GWN76xx Firmware Release Notes

[04/05/2024] FIRMWARE VERSION 1.0.25.18

GWN7660/GWN7660LR

- **Added L2TPv3 tunnel support.**

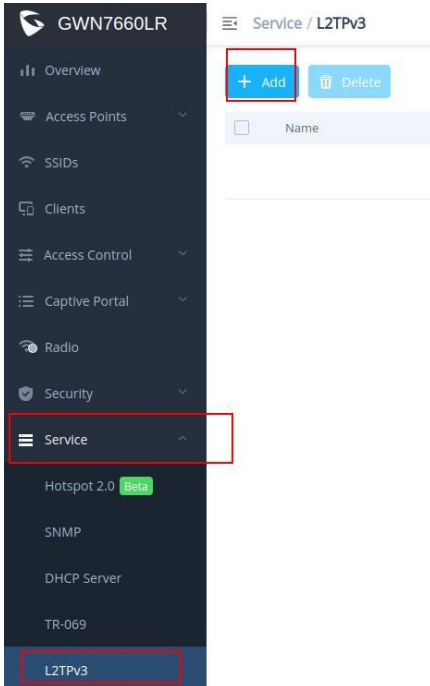
- Added **L2TPv3** tunnel support
- Internal bug fixes

This feature will allow admins to enable and configure L2TPv3 on the device. Please refer to the screenshots and options below.

Note: It is best to set the MTU to match the server to avoid network connectivity issues.

- **Name:** Set the name of the tunnel.
- **Encap Type:** Set the encapsulation type of the tunnel. Valid values for encapsulation are: UDP, IP.
- **Remote Server Address:** Set the IP address of the remote peer.

- **Local Tunnel ID:** Set the tunnel id, which is a 32-bit integer value. This uniquely identifies the tunnel.
- **Remote Tunnel ID:** Set the peer tunnel id, which is a 32-bit integer value assigned to the tunnel by the peer.

- **Local Session ID:** Set the session id, which is a 32-bit integer value. This uniquely identifies the session being created. The value used must match the peer_session_id value being used at the peer.

- **Remote Session ID:** Set the peer session id, which is a 32-bit integer value assigned to the session by the peer. The value used must match the session_id value being used at the peer.

- **Local Cookie:** Set an optional cookie value to be assigned to the session. This is a 4 or 8 byte value, specified as 8 or 16 hex digits, e.g. 014d3636deadbeef. The value must match the peer_cookie value set at the peer. The cookie value is carried in L2TP data packets and is checked for expected value at the peer. Default setting is no cookie used.

- **Remote Cookie:** Set an optional peer cookie value to be assigned to the session. This is a 4 or 8 byte value, specified as 8 or 16 hex digits, e.g. 014d3636deadbeef. The value must match the cookie value

set at the peer. It tells the local system what cookie value to expect to find in received L2TP packets. Default is no cookie used.

- **Tunnel VLAN ID:** The tunnel ID must be set in SSID, and make sure that SSID only has the AP(s) who enabled L2TPv3.
